## FOUNTAIN VIEW AKA STONERIDGE WEST II JSP18-30

Public hearing at the request of Acqaira Realty Holdings for approval of Preliminary Site Plan, Phasing Plan, Wetland Permit, and Storm Water Management Plan. The subject property is located in Section 10 of the City of Novi north of Twelve Mile Road and west of Novi Road. The applicant is proposing to construct three medical and professional office buildings totaling 40,240 square feet with associated site improvements.

## PLANNING REVIEW

**Review Date:** August 17, 2018  
**Review Type:** Preliminary Site Plan  
**Project Name:** JSP18-30 Stoneridge West II  
**Location:** 44244 W. Twelve Mile Road; Parcel 22-10-400-067  
**Plan Date:** 7/31/2018  
**Prepared by:** Lindsay Bell, Planner  
**E-mail:** lbell@cityofnovi.org; **Phone:** (248) 347-0484

**SHEET**  
 Phase Plan

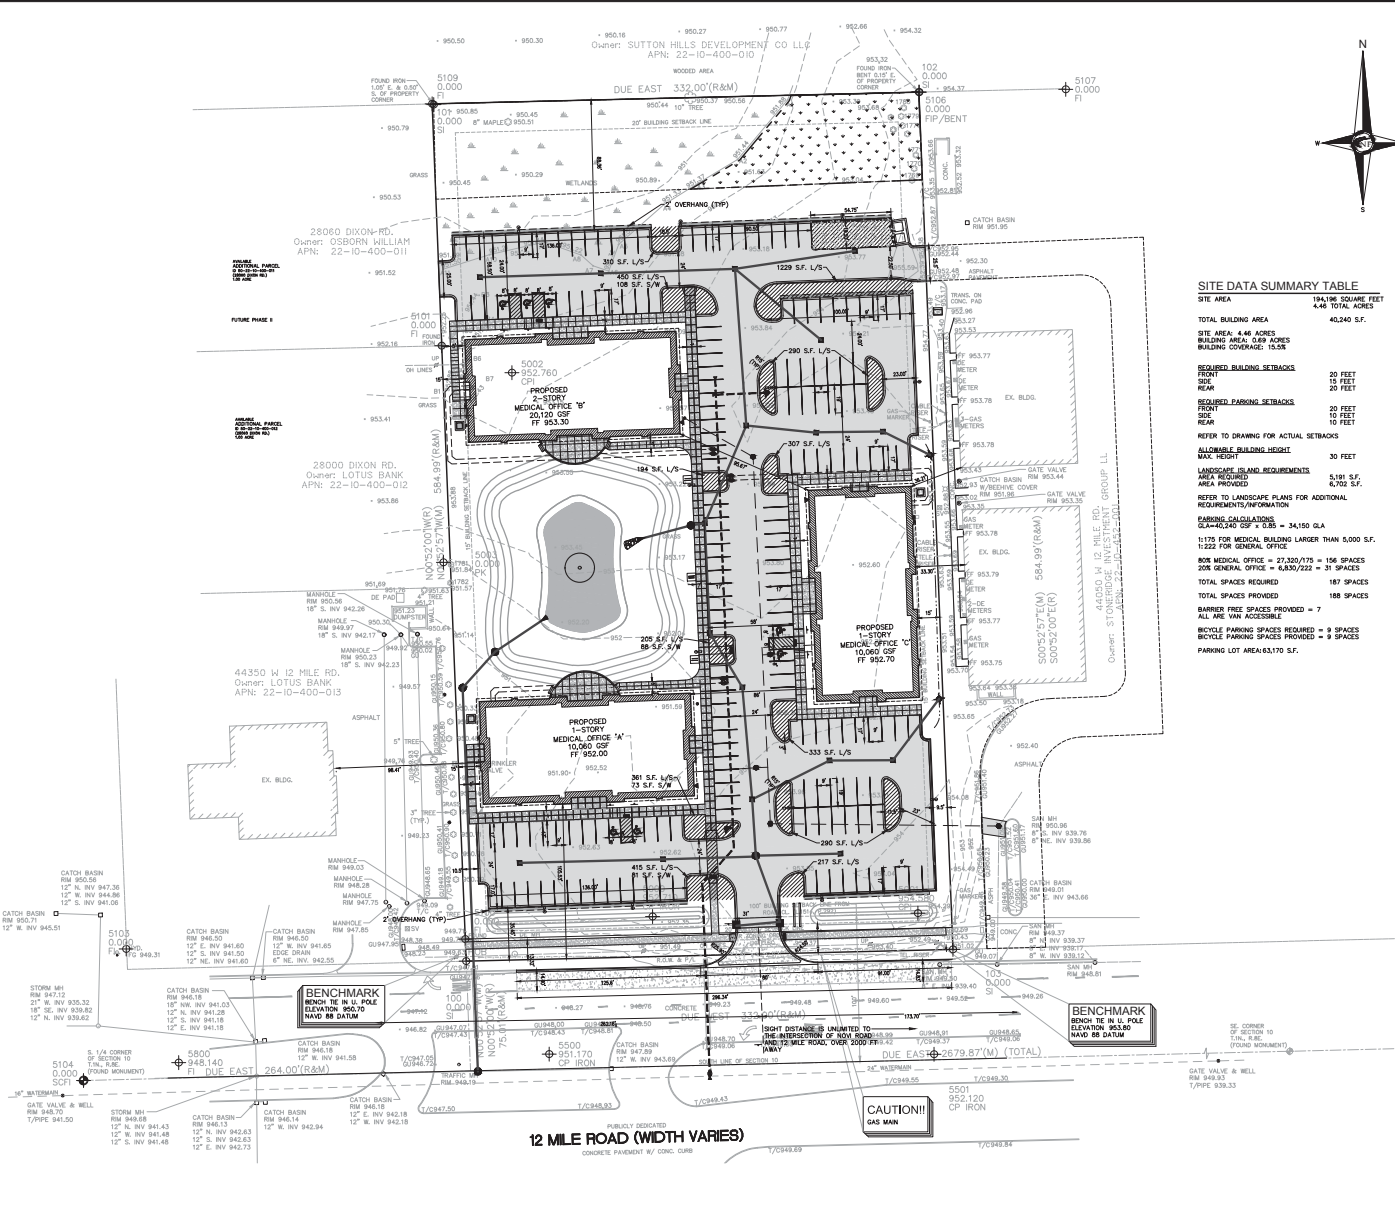
1. Phasing Plan (Sec 4.19.2.A): The application indicates 2-3 phases of development, however no phasing plan with phase lines has been included in the plan set. Applicant has indicated the entire site will be prepared, including pad sites for all three buildings, with construction of individual buildings to be built in phases. **If the applicant believes construction of the project will exceed 2 years, staff recommends that a phasing plan sheet be included for Planning Commission approval. Such phasing plan should clearly delineate all features, including structures, utilities and landscaping, that will be provided in each phase.**

1  
FRONT VIEW-BUILDING 'B'  
Scale: 1/8" = 1'-0"

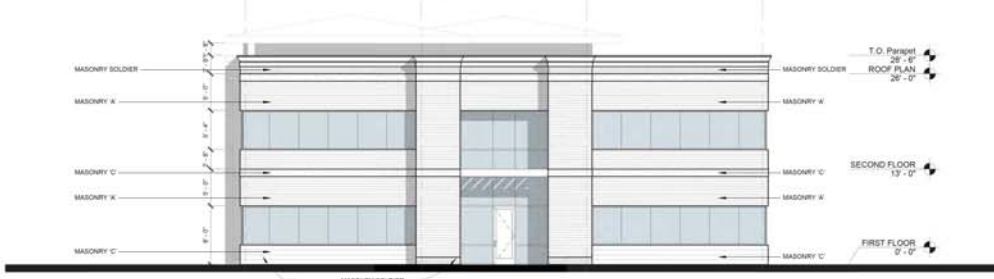
- a. For buildings A & C, a Section 9 waiver to allow the overage of Burnished CMU on all facades (10% allowed; up to 20% proposed), an underage of Brick on the rear, left and right facades (30% required; minimum 20% proposed) and an overage of Standing Seem Metal on rear, left and right facades (25% allowed; up to 36% proposed). *These deviations are supported because the buildings exhibit well balanced composition and the proportions of materials used are consistent with and will enhance the overall design, and overall the building is consistent with the intent and purpose of the Façade Ordinance.* The Section 9 waiver is hereby granted;
